Subject: Supplement to Original Application for Certification of 900/2400MHz Spread
Spectrum Cordless Telephone System, Panasonic Model KX-TG2550 Series
Base Unit, FCC ID: ACJ96NKX-TG2550

This is in response to your correspondence reference number 8310 and our telephone conversation of June 19, 1999 regarding processing gain test for the subject application that was assigned Form 731 Confirmation Number EA94139.

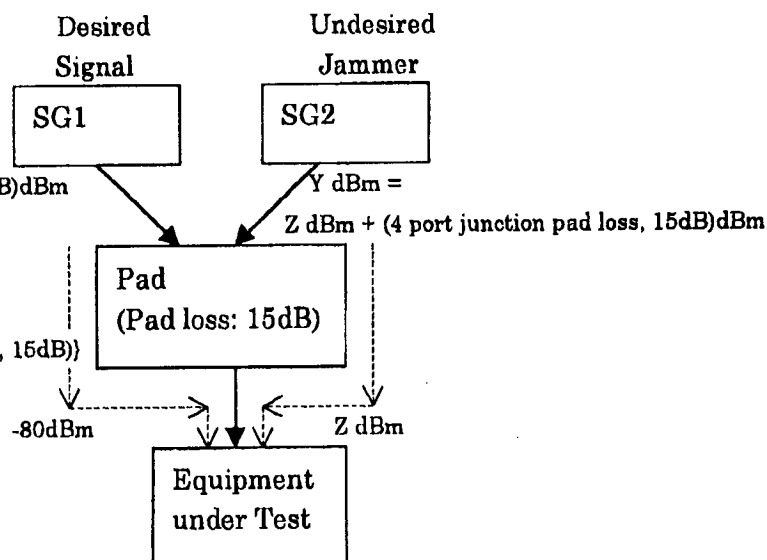
Attached find the factory's response regarding processing gain test setup and explanation regarding desired SG1 and undesired SG2 settings during measurements that demonstrated 15.5dB processing gain for the base unit. I hope this can resolve this remaining outstanding item.

Both the Desired Signal and Undesired Signal go through the same pad (Pad Loss : - 15 dB).

4 port junction pad loss is 15 dB.

Desired Signal Level at the input of receiver is -80dBm.

$-80\text{dBm} + (4 \text{ port junction pad loss, } 15\text{dB})\text{dBm}$

Jamming Margin =

$Y \text{ dBm} - \{-80\text{dBm} + (4 \text{ port junction pad loss, } 15\text{dB})\}$
